ERRATA FOR IEEE 1394b THREE-PORT CABLE TRANSCEIVER/ ARBITER TSB81BA3, TSB81BA3I (SLLS559) AND TSB81BA3-EP (SGLS194)

SLLZ015C – DECEMBER 2002 – REVISED MARCH 2006

TSB81BA3 Silicon Errata

This document contains corrections and additions to the following device data sheets: TSB81BA3 (TI Literature Number SLLS559) and TSB81BA3-EP (TI Literature Number SGLS194).

Figure 1. BOSS Arbitration Issue Caused By Mixed Cable Lengths

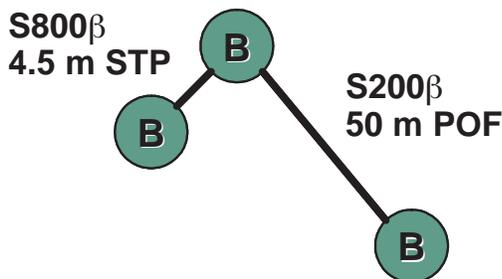
2. BOSS arbitration issue	<p><u>Symptom</u> A bus-reset may occur in certain topologies when 1394b BOSS arbitration is in use.</p> <p><u>Occurrences</u> This issue is only possible if three or more BOSS-arbitration capable nodes are connected through a 1394b connection. To be BOSS-arbitration capable a node must have a 1394b PHY and a 1394b Link using the 1394b PHY-Link interface connection.</p> <p>If a narrow timing window is violated (dependent on cable lengths and/or mixed speed bus hops) a middle node may detect a packet collision, causing a PHY state timeout. The state timeout causes a bus reset. Repetitive occurrences result in repetitive bus resets.</p> <p><u>Example Topologies</u> A. Mixing short and long cable lengths. A BOSS arbitration issue may occur in the middle node. Figure 1 shows an example topology that would exhibit the condition.</p>	<p>A. Use one or more 1394a link-layer controllers (LLCs). If the network only consists of nodes using 1394a link layers, then BOSS arbitration is not utilized; Gap_Count delays are maintained and therefore nodes are not affected by this errata.</p> <p>B. In nodes that do not have a link, disable BOSS arbitration (e.g., force the BMODE pin to the logic 0 state).</p> <p>C. Use a topology where all nodes use the same 1394a compatible bus speed (e.g., S400) and at least one IEEE Std 1394a-2000 node is present.</p> <p>D. Use a topology where all 1394B nodes are at the same 1394b bus speed, using matched cable lengths between 1M and 4.5M.</p>

Figure 2. BOSS Arbitration Issue Caused By Mixed Bus Hop Speeds

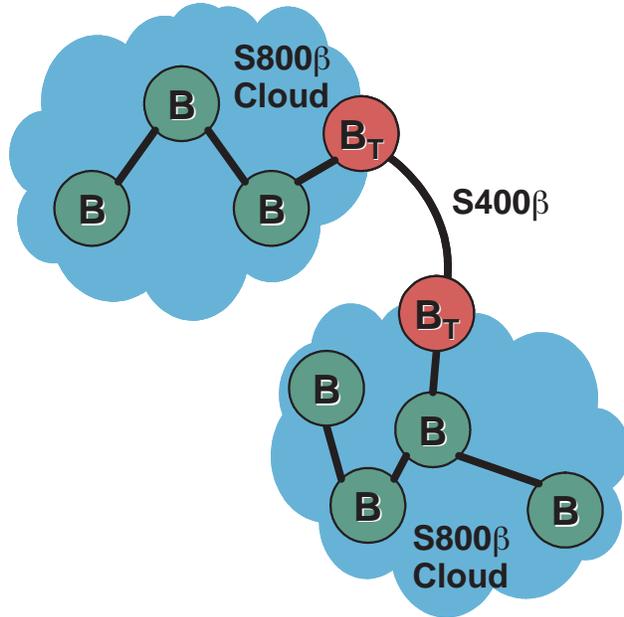
SILICON ERRATA ID	PROBLEM DESCRIPTION	RESOLUTION / WORK-AROUNDS
2. BOSS arbitration issue (continued)	<u>Example Topologies</u> (continued) B. Mixing bus hop speeds. Either transition node (B_T) may have a BOSS arbitration issue. See Figure 2.

Figure 3. BOSS Arbitration Issue—Detailed Example Situation

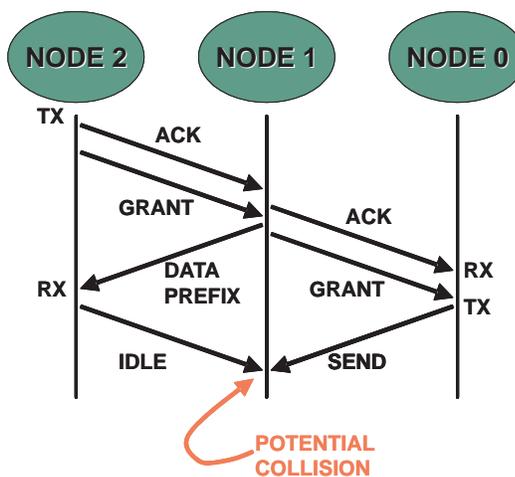
SILICON ERRATA ID	PROBLEM DESCRIPTION	RESOLUTION / WORK-AROUNDS
2. BOSS arbitration issue (continued)	<p><u>Detailed Example Situation</u> See Figure 3.</p> <ol style="list-style-type: none"> 1. Node #2 transmits a high-speed packet that ends an Async subaction or the Isoch period. 2. Node #2 advances the Async phase (no requests pending for the current phase). 3. Node #0 has a bus request pending for the new phase. 4. Node #2 sends an Async grant. 5. The Async grant is forwarded through a senior node (Node #1) and down through a junior connection to Node #0. 6. If a narrow timing window is violated the middle node (Node #1) will detect a packet collision, causing a state-timeout while forwarding the grant to the next node. The state-timeout will cause a bus reset.
